APPEAL SUMMARY

Appeal ID: 23394

Building/Business Name: Madison High School

LUR or Permit Application No.: 19-116412-CO

Sheet Title
GRANDSTAND - SECTIONS

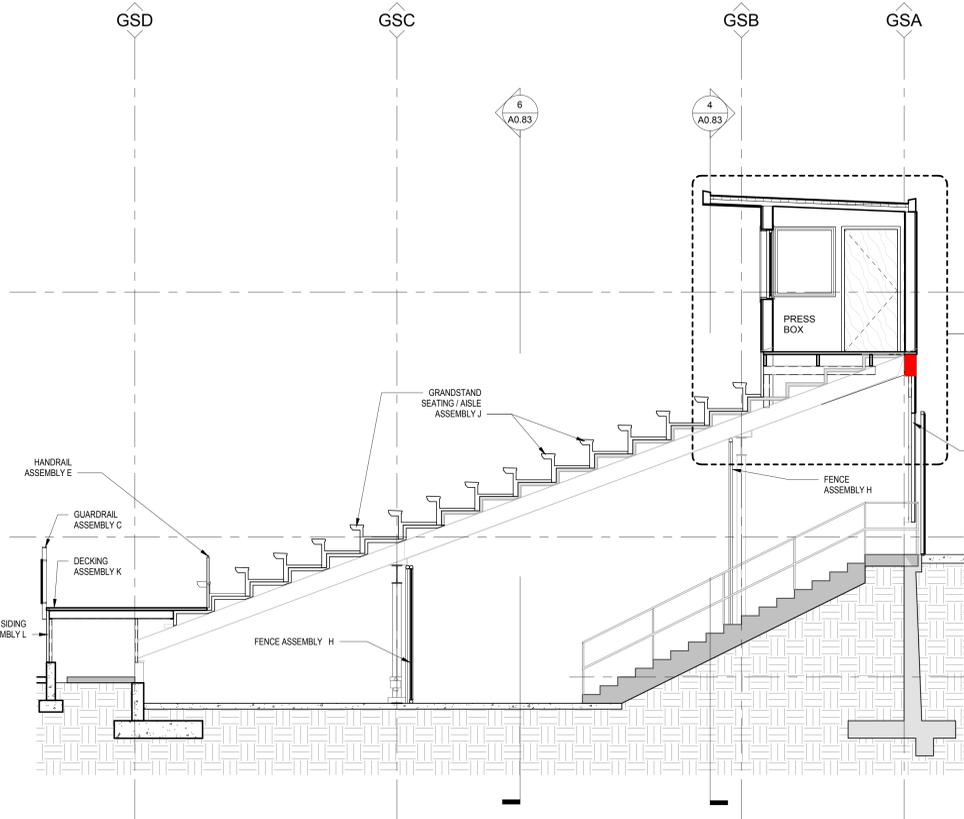
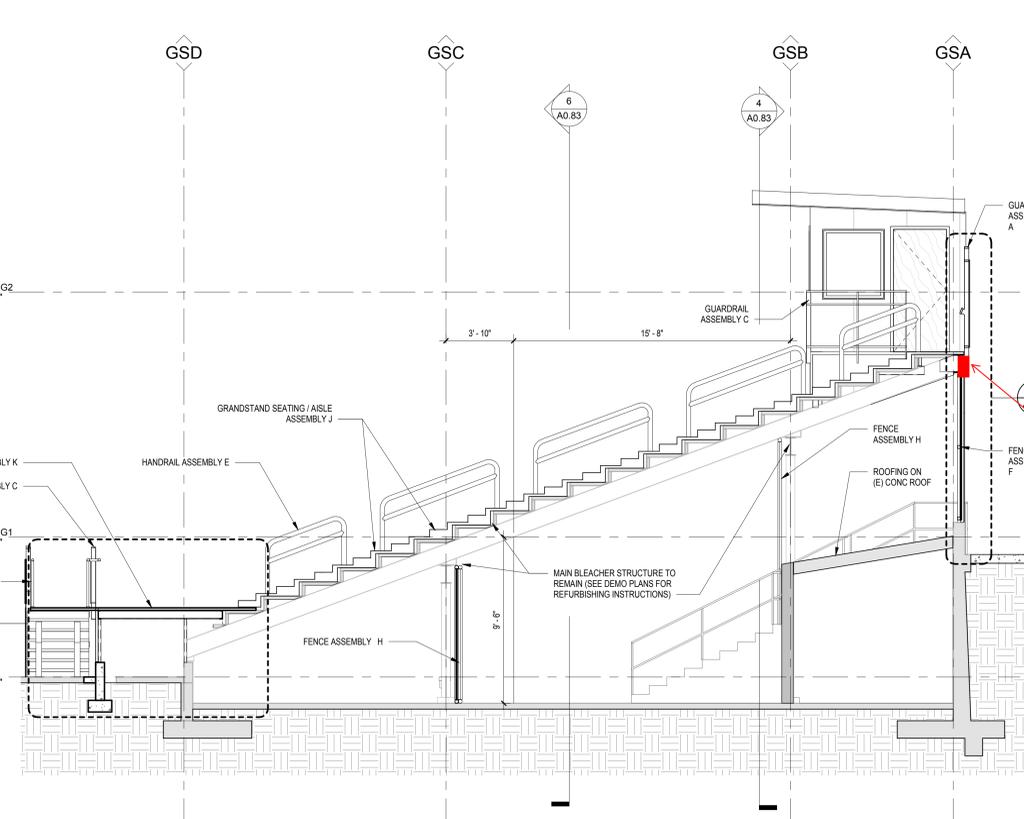
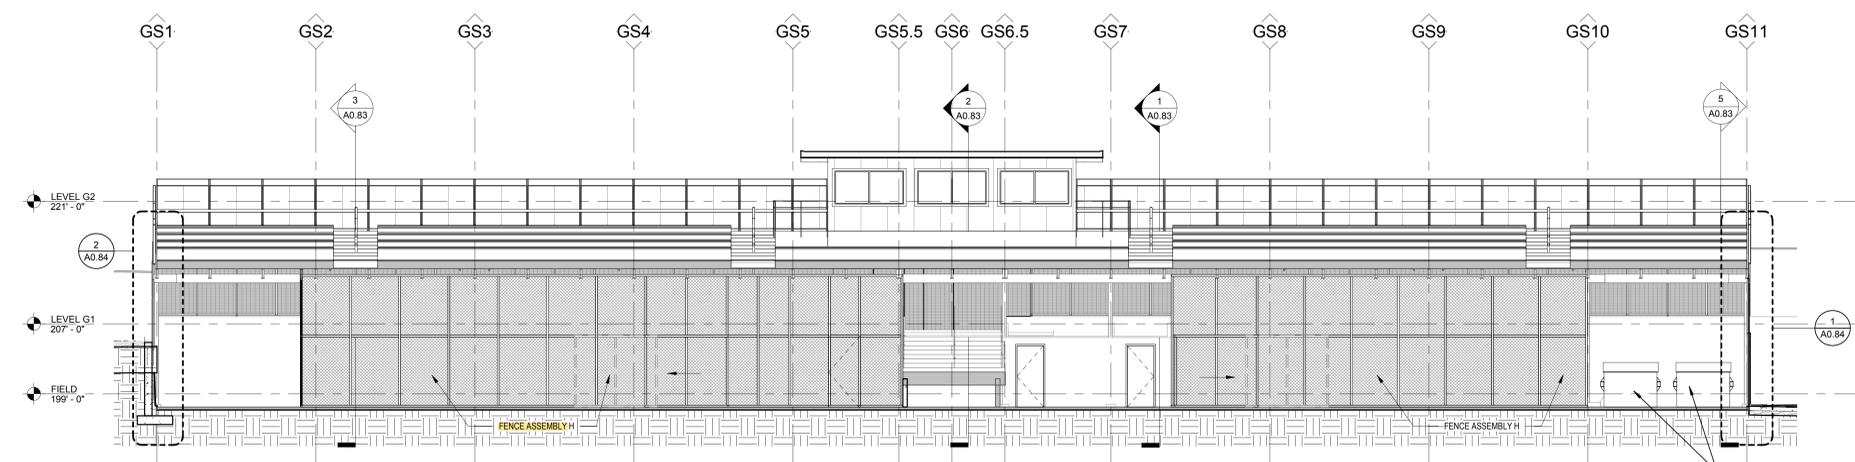
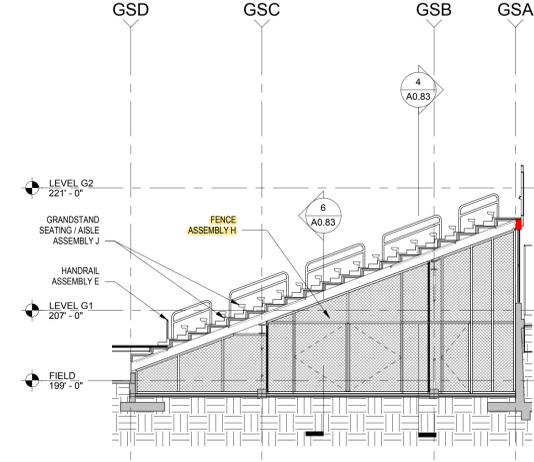
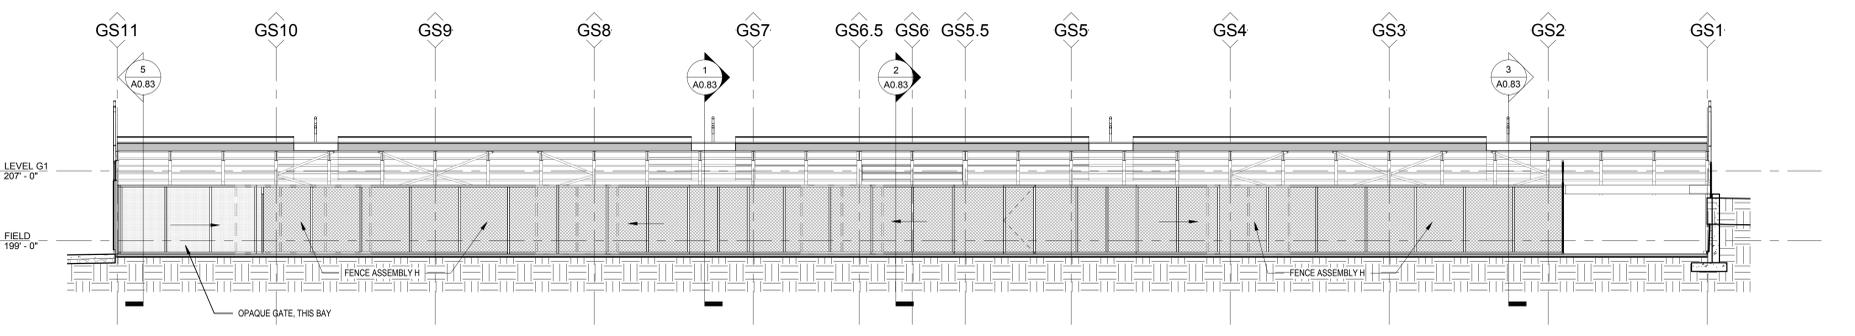
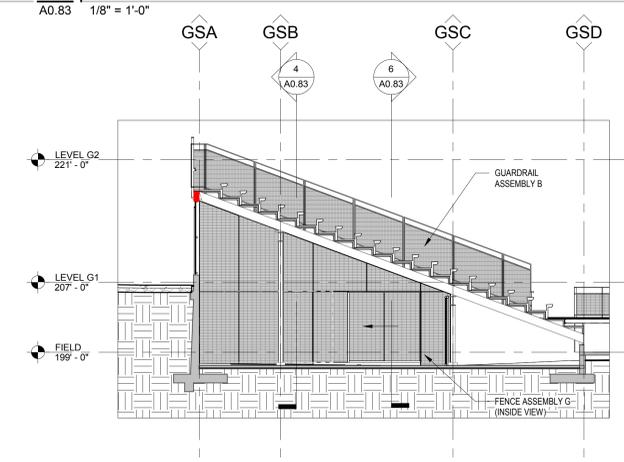
- Sprinklers will be provided underneath the Grandstands per NFPA 13.
- A continuous draft stop will be provided at the high side of the Grandstands to act as a heat collector for sprinkler activation. It will be a minimum of 12 inches in height.
- The storage areas underneath the bleachers will be separated by non-rated solid barriers such that each no storage area exceeds 1,000 sf.

Reason for alternative The area under the Grandstands will be used for storage of outdoor sporting equipment and small utility vehicles. Separation in this condition is typically provided at the ceilings and walls of rooms below. Due to the exterior installation of these Grandstands, however, the storage is separated only by the structure of the seating area above and by fencing around the perimeter. Though the seating separation is continuous and solid, and the fencing consists of solid panels, it is not an air-tight or fire-resistance-rated barrier separation. Because the structure is prefabricated and the storage is not completely enclosed, adding a 1-hour fire-resistance rated assembly is not a feasible means of separation for this design, particularly at the ceiling.

1. Use of sprinklers below grandstands for separation of storage space in lieu of 1 hour fire rated separation: Granted provided notification is provided for the grandstands only with installation per NFPA 72.

Sheet Title
**ENLARGED
PLANS - STAIR 6
& 6A**

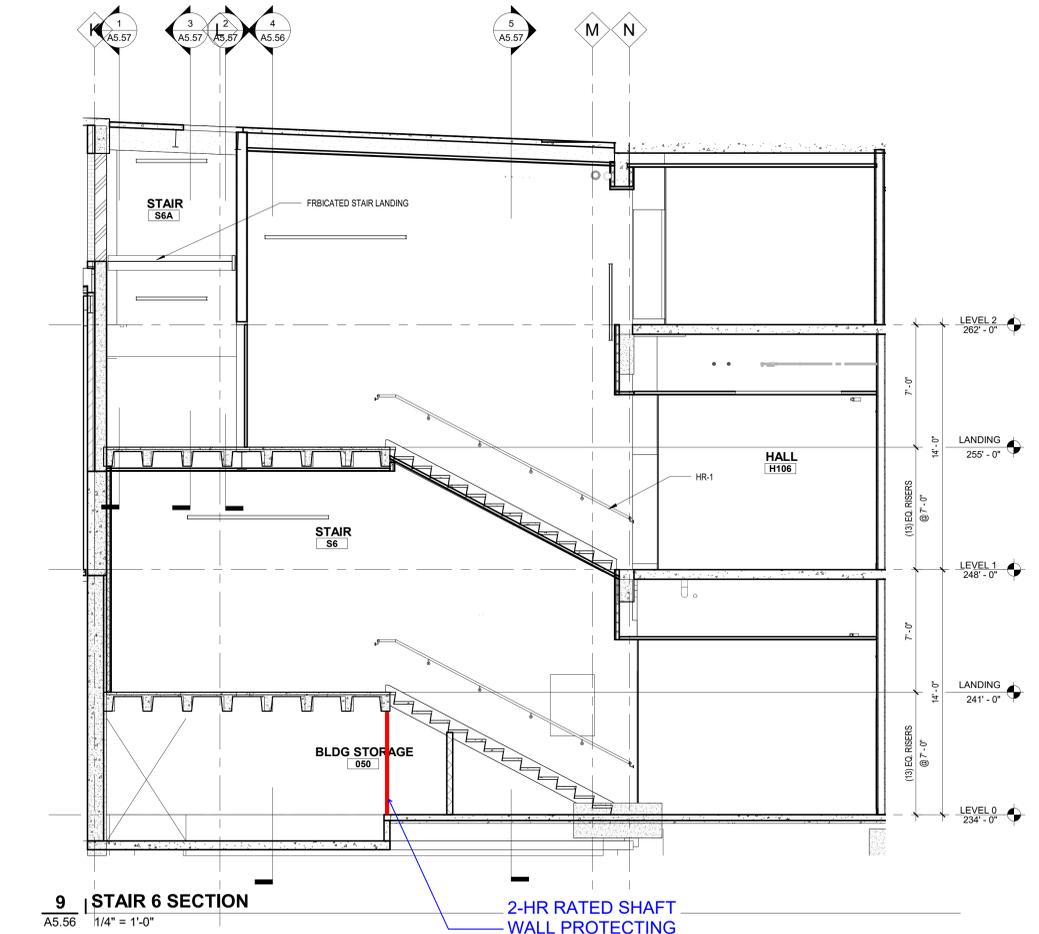
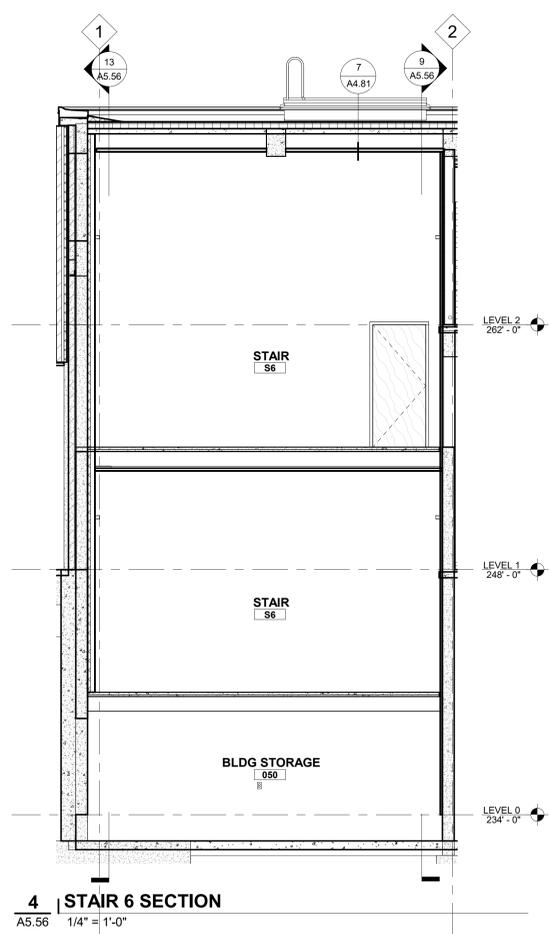
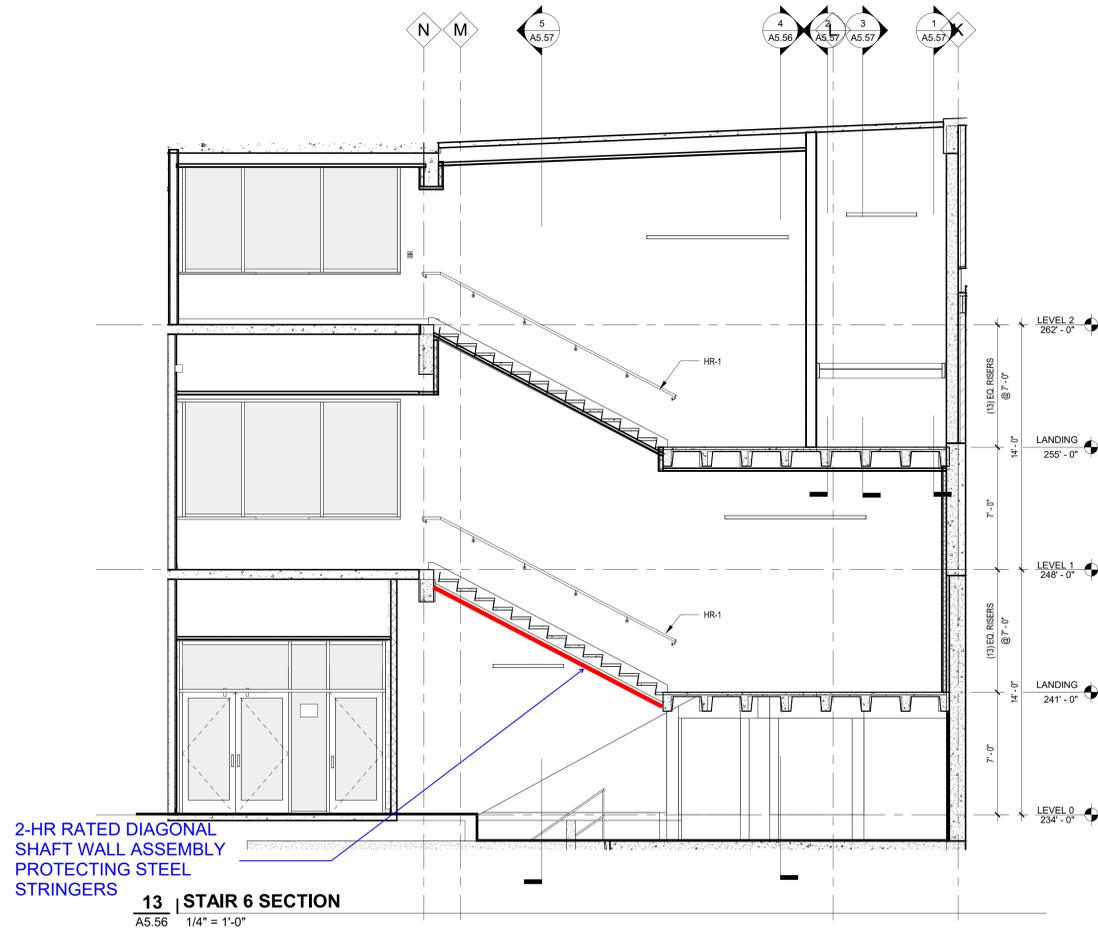
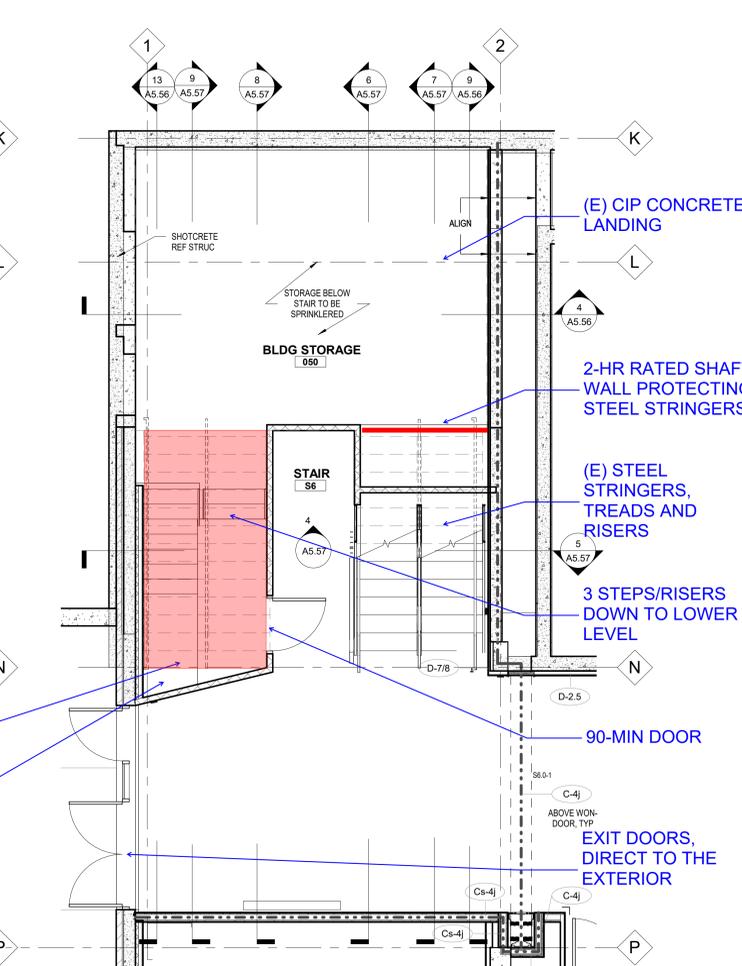
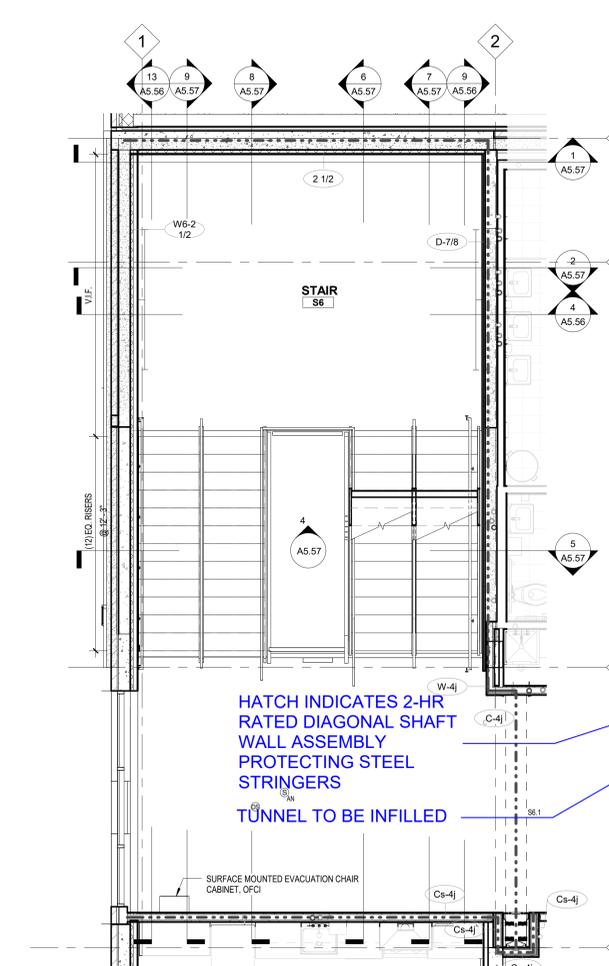
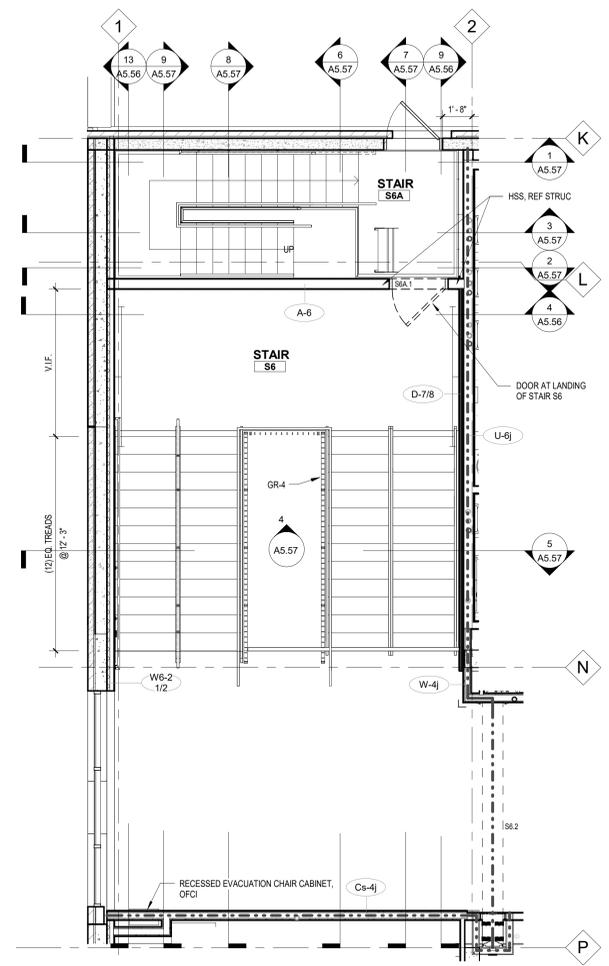
Code Modification or Alternate Requested It is requested that access to the storage area under the interior exit stairway be allowed to be provided from within the stair enclosure as shown on Level 0.

Proposed Design The Madison High School Main Building contains an existing interior exit stairway, identified as Stair 6; both the stair construction and the enclosure are existing and will remain. Stair 6 is separated from the rest of the building by concrete shear walls that provide a minimum 2-hour fire-resistance rating. There is existing storage below the stair at Level 0 that will be enclosed and separated from the rest of the stair by 2-hour fire-resistance-rated construction at the walls and soffit. Access to the storage area is proposed from within the stair enclosure.

Reason for alternative Providing access to the storage area below the stair from outside the stair is infeasible. This is due to the existing construction of the stair core; it is separated from the rest of the building by existing concrete shear walls at the interior and an existing concrete retaining wall at the exterior. At the shear walls, cutting an opening for access would be both difficult and would compromise the structure. At the retaining walls, the adjacent grade would make it impossible.

In both the existing and proposed design, the area underneath the stair is used for storage. However, in the existing design it is not enclosed. In the proposed design, it is enclosed and separated by 2-hour construction, thus making the condition for egress at the stair safer.

In addition, access to an exterior exit door from the enclosure is provided directly adjacent to the storage area on Level 0. This will allow occupants to egress quickly from the area where the storage is contained.

2. Access to storage space below interior exit stairway from within the stair enclosure: Granted as proposed. Appellant may contact John Butler (503 823-7339) with questions.
